Research Note 85-1

SINGARS-V MATURITY OPERATIONAL TEST:  
HUMAN FACTORS EVALUATION (SYNOPSIS)

January 1985

Figure 1. SINGGARS-V Advanced Development Model. Front Panel.

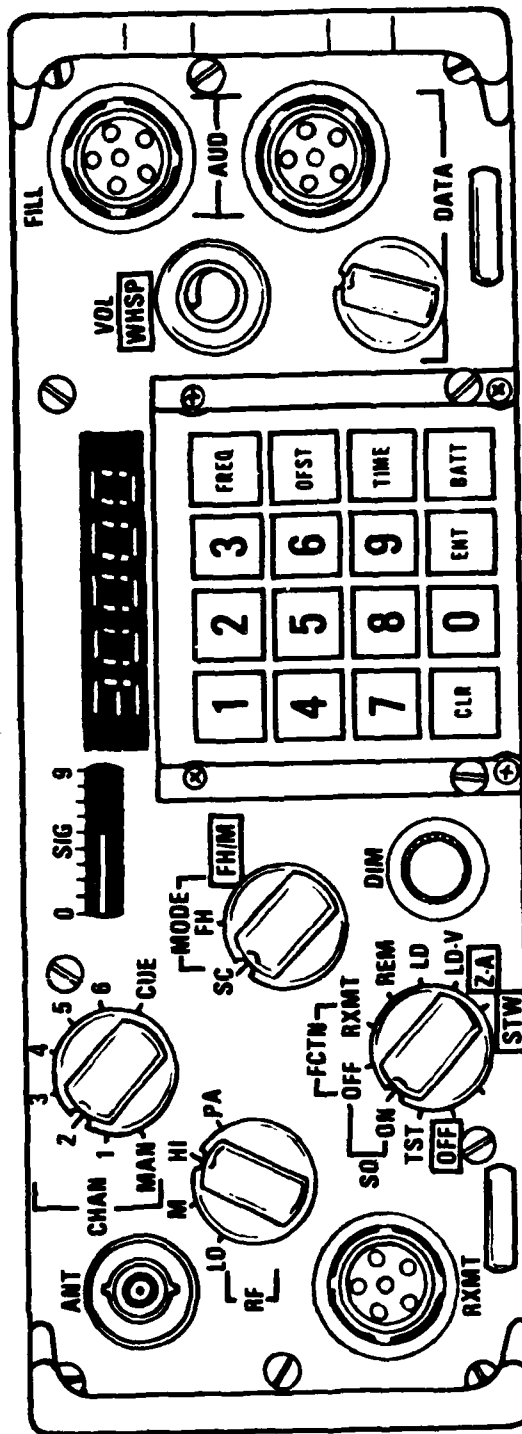
30. The LED display is recessed into the RT front panel so that visual angles greater than about 20 degrees above or below center cut off part of the display. Placement of the RT lower than the operator's eyes seems to be the greater problem. The cut-off of the display, especially from above, resulted in almost a two-hour delay in communication in one field incident. The display should be changed so that it can be accurately read from viewing angles up to 45 degrees.

31. The seven-bar LED display cannot configure a complete alpha-numeric character set. Hence, messages must conform to this limitation, which causes cryptic and difficult-to-understand messages and prompts. Consideration should be given to alternative displays (e.g., nine-bar, or 7 x 9 dot matrix). The display limitation contributes to the "user unfriendliness" of the RT and its software. A means should be created to provide meaningful prompts in a visual form to the operator.

35. The control panel is so crowded that individual controls were not discernable in a night operation using passive night vision goggles. The configuration of controls on the control panel should be reviewed for visibility and improved where possible.

40. The front panel is cluttered by having too much designed into insufficient space. This leaves little space for appropriate labeling. This problem could be alleviated to some extent by improving the labeling and perhaps eliminating unessential labels such as FCTN, CHAN, MODE, and RF.

42. The labeling on the data selector switch is hard to read. The paint wears off, and the markings become invisible. The markings on the switch should be engraved, filled, and sealed.

46. SC controls are intermixed with FH controls. Operation of the RT as a SC radio is complicated by the confusion of controls and their functions. FH and SC controls should be grouped apart to facilitate operator training and use of the RT as a SC radio.

47. The antenna connector on the face of the RT tends to become loose. It is extremely difficult to tighten because of its proximity to the panel guards. The front panel design should insure that the antenna connector can be easily tightened if it becomes loose.
